# Access Compliance Report

## Public Rights-of-Way

### (Pedestrian Signals)

Intersection ID: N/A	Main Street:	Cross Street: N/A	Location: N/A
ADA ID: A30FFE103EE4	Signal Type: One Push Button-Non APS	Overall Compliance: No	Severity Score: BTN 1: N/A BTN 2: N/A No BTN: N/A
Codes/Mitigation Info/Possible Solution		Field Measurements/Component Compliance

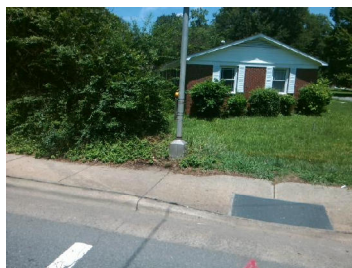
PROW/ADA: TMUTCD 4e.08, R404.2, R406

Possible Solutions: Replace Signal Push Button With APS Button on New Post. Remove & Relocate Sign.
